PRATT & WHITNEY CANADA  
**SERVICE BULLETIN**

P&WC S.B. No. 41119

TURBOSHAFT ENGINE  
IGNITION EXCITER - REPLACEMENT OF

PT6C-67C

Ignition Exciter - Part Progression  
Figure 1

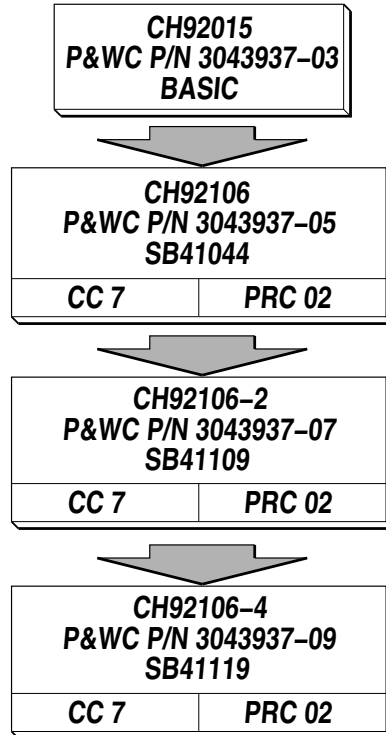
The ignition exciter spider switch is no longer available.

The ignition exciter spider switch has been obsoleted.

Replace the ignition exciter with one that has an available spider switch.

Replace the ignition exciter with a new one.

<u>New P/N</u>	<u>Keyword</u>	<u>Old P/N</u>	<u>Qty</u>	<u>Est. Unit List Price (\$US, 2021)</u>	<u>Instructions Dispositions</u>
	Ignition Exciter (0AFL4) P&WC P/N 3043937-07	CH92106-02	1		(A)(B)
<a href="#">CH92106-04</a>	Ignition Exciter (0AFL4) P&WC P/N 3043937-09		1	Quote	(A)

(A) TWO WAY INTERCHANGEABLE (ATA200 Explanation Code 02): The old or the new parts can replace the old or the new part.
